## Bid Bulletin No. 9

### PUBLIC BIDDING No. 20 – 022– 3

## CONSTRUCTION OF ASCOM FACILITIES AT CAMP AQUINO, TARLAC FOR THE BASES CONVERSION AND DEVELOPMENT AUTHORITY

**SECTION VII  
Drawings  
Volume 2  
S31-1**

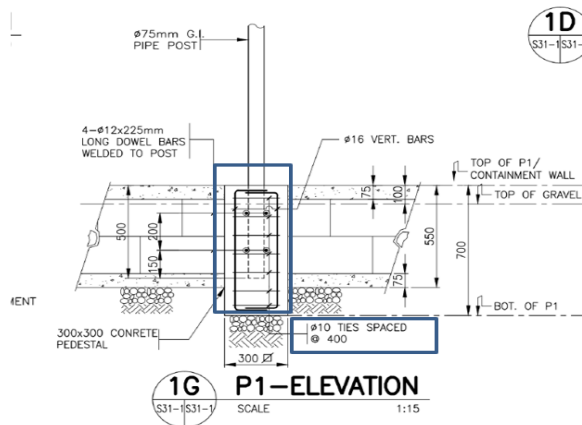
Please confirm if the ties is spaced at 400mm (conflict with the drawing)

Ties are spaced at 100mm.

**S13-5**

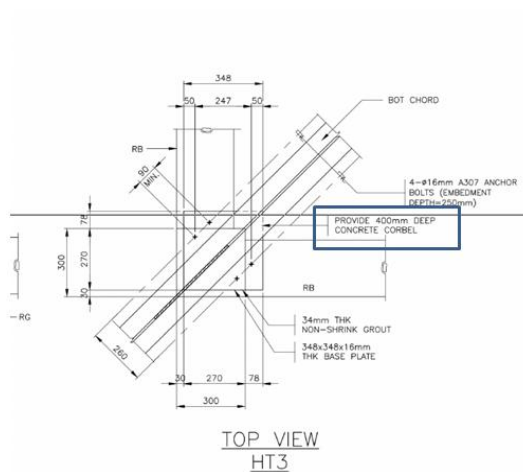
Please verify if the corbel to be used in Building 13 is concrete, conflict with the BOQ (steel corbel)

Concrete corbel shall be used.

**375.3126**

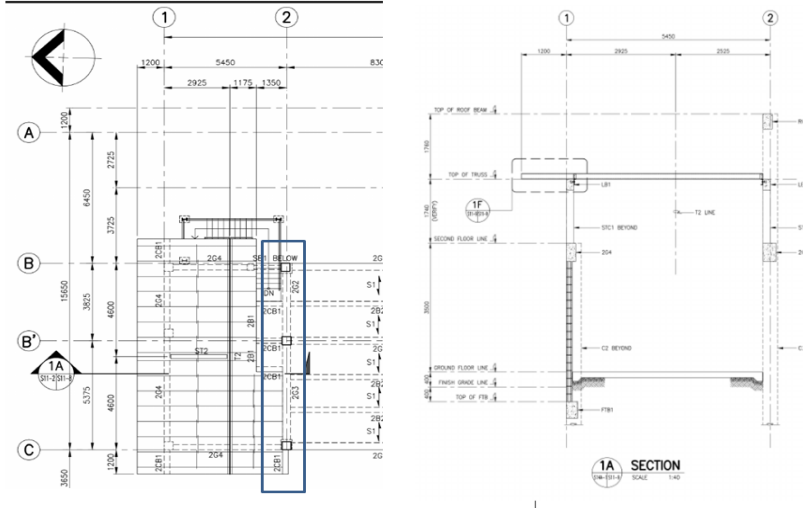
Structural Steel, Steel Corbel (Channel Bar Sections)

Concrete corbel shall be used.

**SECTION VII  
Drawings  
Volume 2  
A20-2**

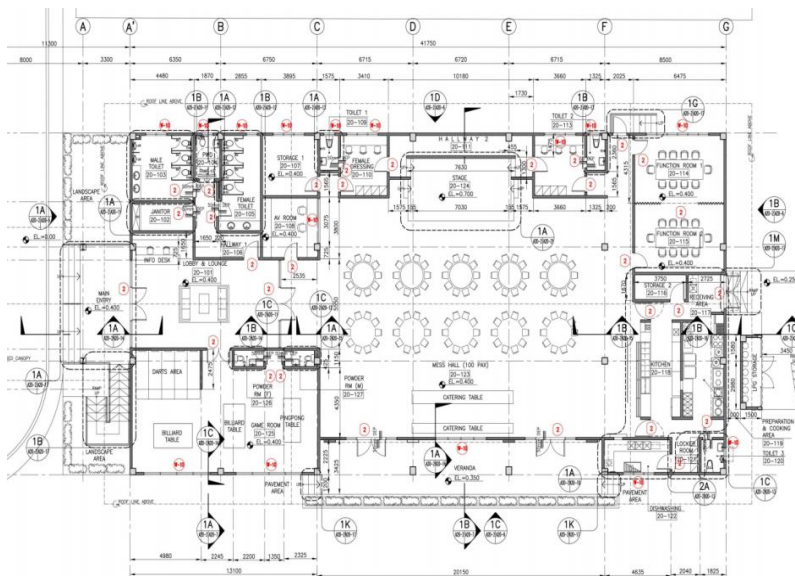
Kindly confirm if this is the door tagging for Building 20, conflict with the door schedule

Refer to attached drawing file for the door & window tag.
